Illinois Tollway Standard Drawing Revisions
--

Section H	Roadway Lighting	
Standard	Modification Summary	Effective: 03-01-2023
H1-11	LIGHT STANDARD FOUNDATION	
Sheet 1	Revised v1(E) bars from #6 to #8.	
Sheet 3	Revised plan view detail dimensions of the median barrier to match section A-A and v1(E) bars from #6 to #8.	
Sheet 4	Revised plan view detail dimensions of the median barrier to match section D-D, the length on anchor bolt detail to 6'-8 3/4" and v1(E) bars from #6 to #7. Added note for anchor bolt length for slip forming.	
Sheet 5	Revised plan view detail dimensions of the median barrier to match section A-A and v1(E) bars from #6 to #7.	
Sheet 10	Revised v1(E) bars from #6 to #8.	
H18-02	PARKING LOT LIGHT FOUNDATION	
	Revised v1(E) bars from #6 to #8

LIGHT STANDARD FOUNDATION

STANDARD H1-11

LIGHT STANDARD FOUNDATION DETAILS - CONCRETE
(GROUND MOUNTED UNITS)

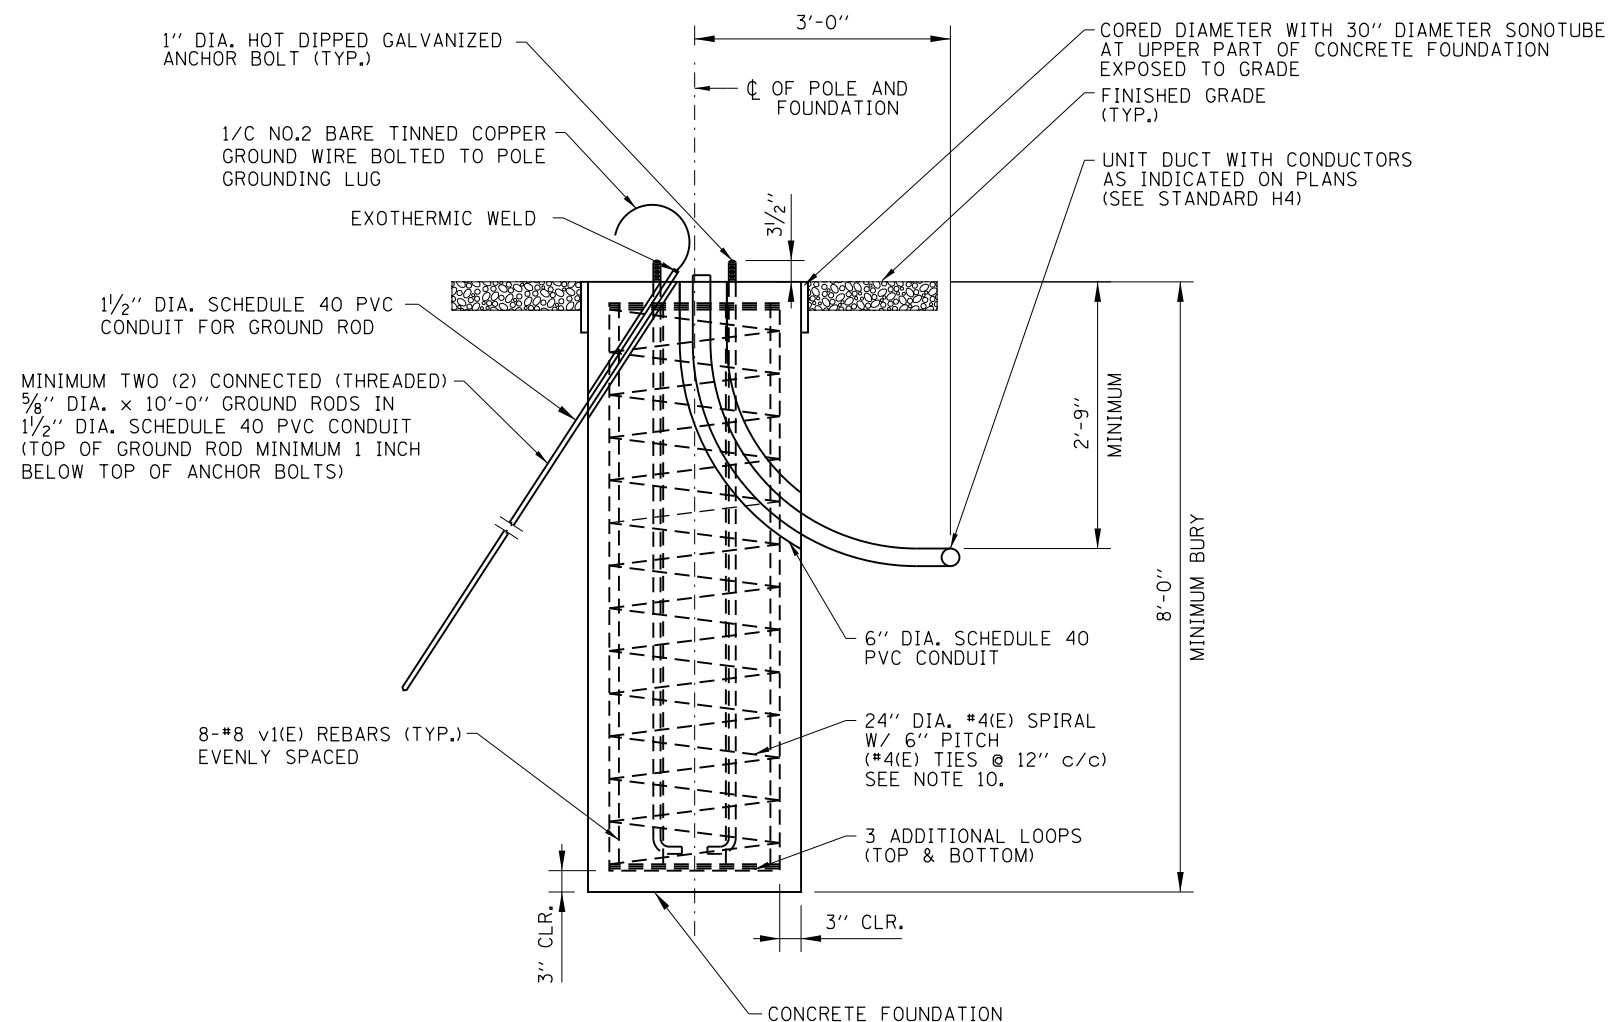
DATE	REVISIONS
3-01-2023	ADDED ANCHOR BOLT NOTE. REVISED PLAN DIMENSION OF MEDIAN BARRIER TO MATCH SECTION A-A. REVISED PLAN DIMENSION OF MEDIAN BARRIER TO MATCH SECTION D-D & THE LENGTH OF ANCHOR BOLT DETAIL TO 6'-8 3/4". REVISED PLAN DIMENSIONS OF THE MEDIAN BARRIER TO MATCH SECTION A-A.

ANCHOR BOLT DETAIL

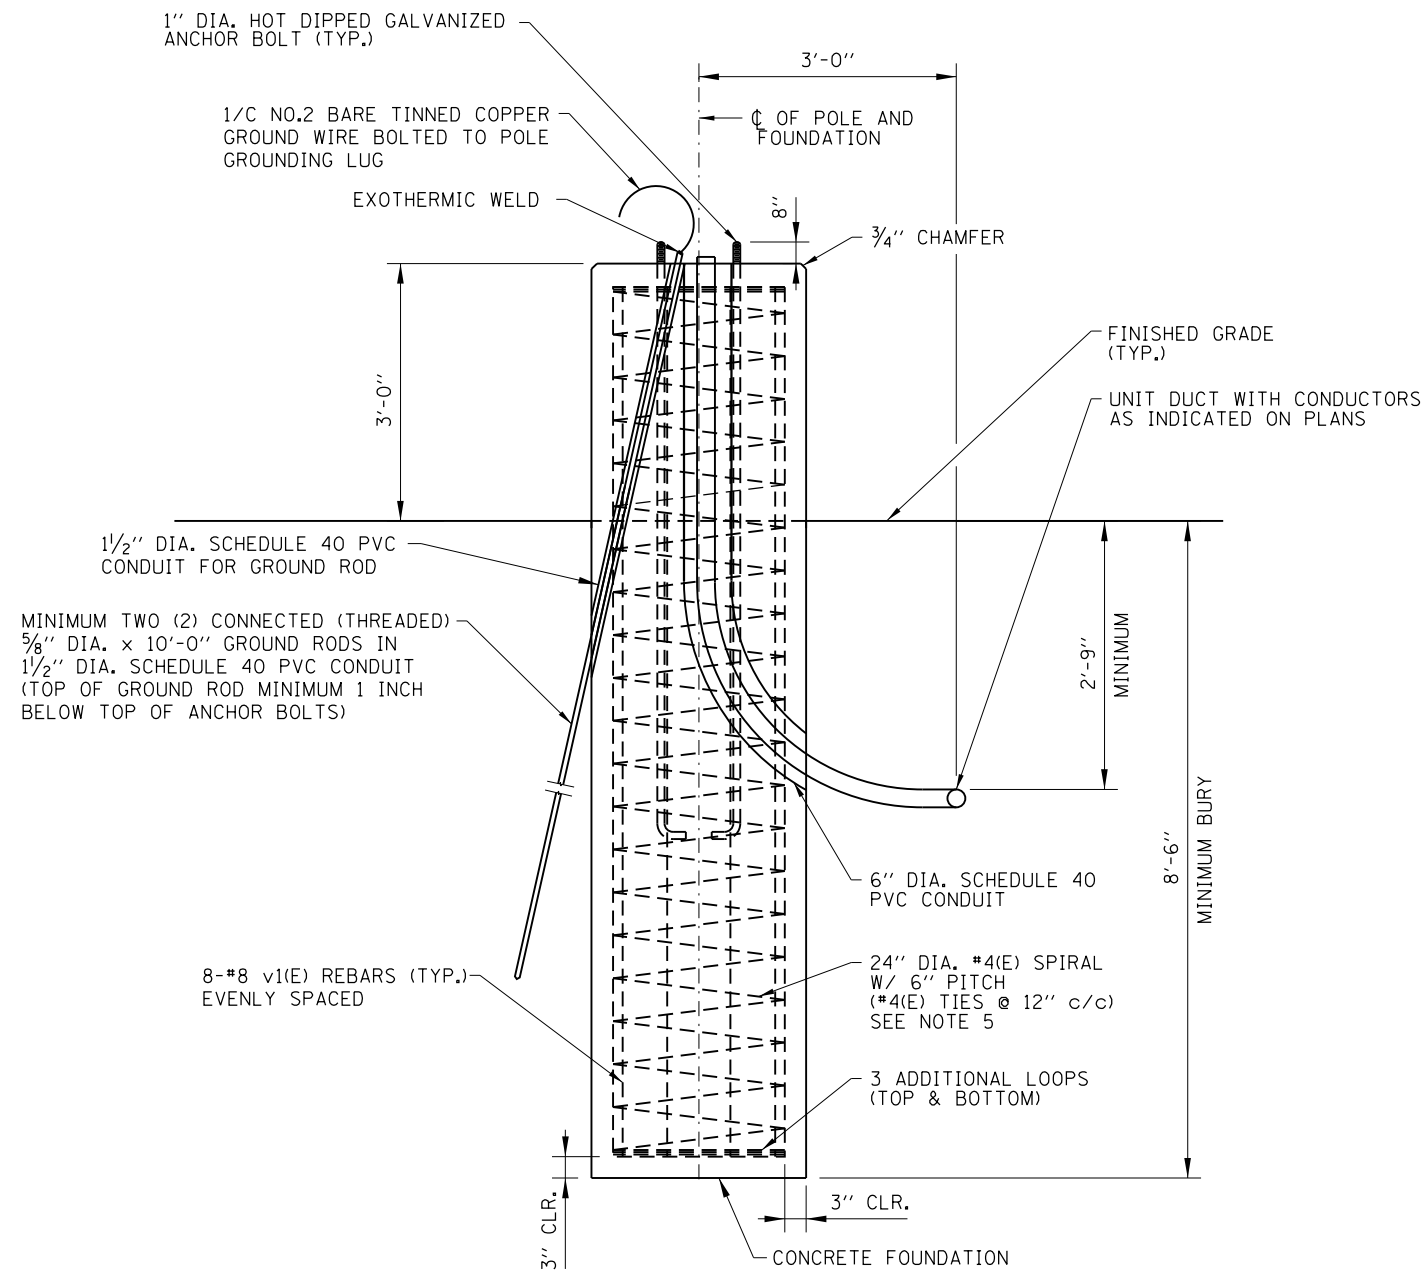
DATE	REVISIONS
3-01-2023	REVISED v1(E) BARS FROM #6 TO #8.
3-01-2022	INCREASED ANCHOR BOLT PROJECTION.
